The Niwot Community Association (NCA), in conjunction with the Niwot Local Improvement District (LID), conducted parallel surveys on the topic of a possible underpass to downtown Niwot from the new Niwot Transit Center & Park-n-Ride that is part of the CO 119 Safely, Mobility, and Bikeway Project.

The following survey results are from validated NCA member responses only.

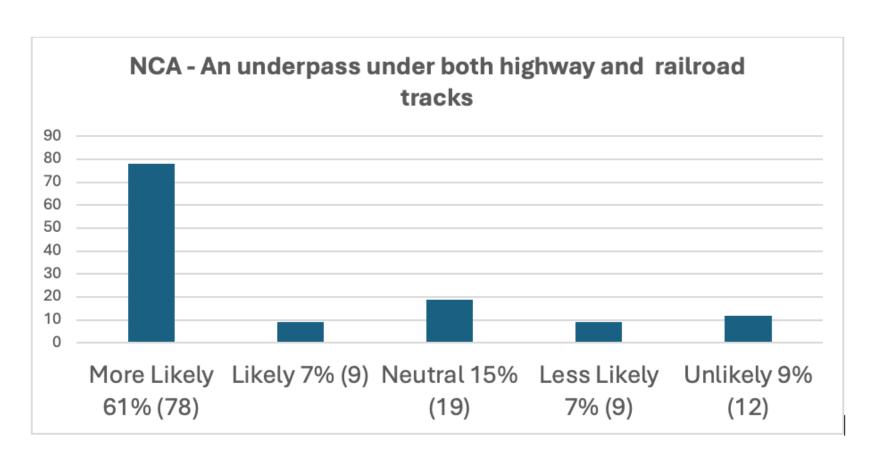
- Option 3a: 30% (38) Option 4: 65% (83)
- I don't know 4% (5)

I think that building the underpass under both the highway and the train tracks is very important for safety and maximizing its utilization.

I also like the shorter distance of option 4. That should encourage pedestrian and transit users.

Please avoid convex mirror, sharp right angle turns into tube and have brighter tunnel lights than airport road tube has (a horrible design)!

3a seems most visible for cyclist and peds entering Niwot at 2nd Ave. Will keep bike and ped traffic out of 1st Ave neighborhood and kid's park. Will put users directly onto 2nd Ave where shopping and restaurants are available. Train track underpass is unnecessary, there are maybe 4 or 5 trains a day through Niwot, I don't mind waiting 5 mins if there happens to be a train present.

It makes more sense to have the underpass go under both the train and road. I also think that it is safer not having to cross the tracks and moving it away from 2nd Ave.

I am concerned about the impact to the WhistleStop Park. The underpass ramp should take away a minimum amount of the park land. I would like to see more details here.

I think 4 is a safer route, and it will not add any distance to pedestrians or cyclists.

I prefer option 3a's entrance onto 2nd avenue which more directly connects cyclists to Niwot's businesses. The crossing at the RR tracks looks like it's at the same place as the car crossing and that feels safe to me. As such the underpass there isn't critical in my opinion.

I think 4 is more direct and would be a nice experience for anyone coming to the some of the events at the park.

The benefit of 3a is it is a really nice continuation of the downtown area which is where we want most of the action. It would also be the most visually obvious place to go and would result in more use as a lot of people would see it over time.

Please plan for keeping water out of the tunnels. Is the plan for light rail over?

Either option would be great, 4 being a slight preference for safety but the extra cost makes 3a acceptable, as well! Dropping into the park seems more pleasant, too.

3a looks like it would be very similar functionally to 4a, and thus the lower cost makes sense to me

My vote would be for option 3a if it passed under the railroad tracks, not across. Not sure why this is not an option

I will generally be using the bikeway so 3a would be a more direct connection to that which I would prefer. 3a will also reduce cyclist/pedestrian conflict when a bus is arriving or departing, again, a better option. 3a is also cheaper.

3a route is not clearly visible from parking. Too long a walk. Too close to traffic. Too exposed to hot sun and chill winds. Will not really be used by pedestrians.

4 is safer from traffic, more visible, appealing, closer, + will help concert attendees. Might actually be used by pedestrians. Cyclists will use either 3a or 4.

Option 4 will serve the Niwot community further into the future. Walking across open railroad tracks is a short term solution and an obvious compromise. I strongly support the dual underpass design of Option 4. Thank you for asking!

Option 4 provides the most direct and obvious entrance to Niwot and events at Whistle Stop Park.

Option 3 is too long. Public transportation to Rock and Rails would be a big asset to the town. Coming across via Option 4 would draw people both to concerts and downtown.

Safety major factor! Walking across railroad tracks makes no sense. Option 3a likely to Force pedestriians to try to cross the highway at ground level and on foot- the LEAST SAFE CHOICE.
